CEFN MAWR EMERGENCY STANDBY
ELECTRICITY GENERATION FACILITY -
SITE ACCESS, SITE COMPOUND LAYOUT
AND SWEEP PATH ANALYSIS

Appendix D SECTION 96A APPLICATION

RE: APPLICATION UNDER SECTION 96A OF THE TOWN AND COUNTRY PLANNING ACT 1990 FOR NON-MATERIAL AMENDMENTS TO PLANNING PERMISSION P/2015/0623 EMERGENCY STANDBY ELECTRICITY GENERATION FACILITY AT LAND NORTH EAST OF CEFN MAWR, PLAS BENION ROAD, PENYCAE, WREXHAM

FIGURE 5.6.2

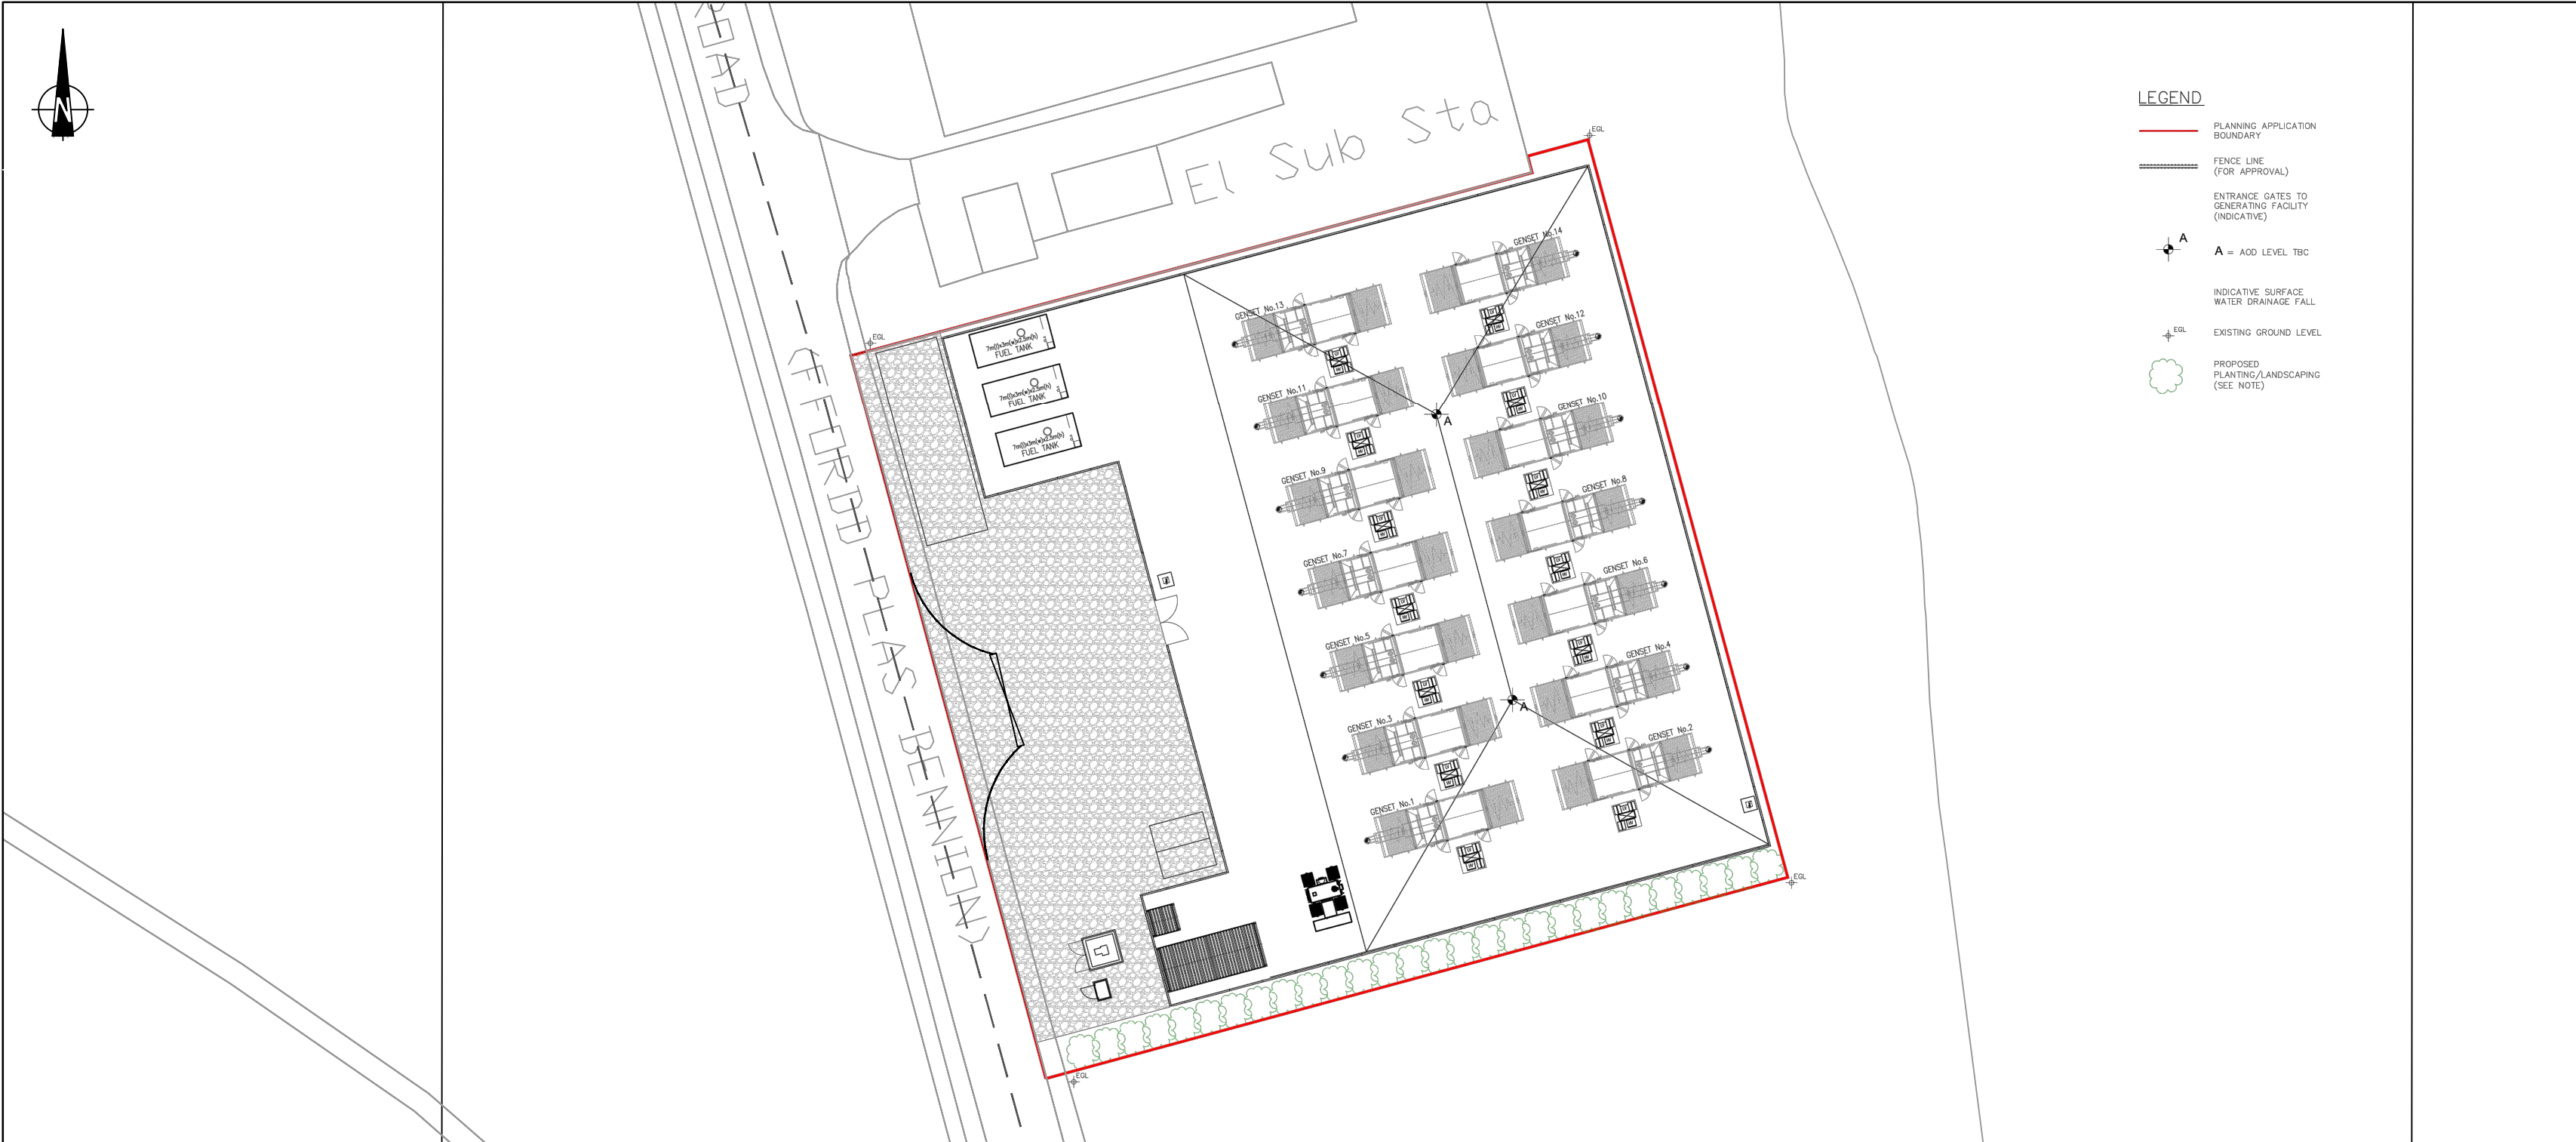
The location of the access has moved 12 m towards the south of the site to provide improved access for fuel delivery. We do not envisage that this will have any material impacts on the surrounding highway network, to the contrary, we anticipate that site access would be improved.
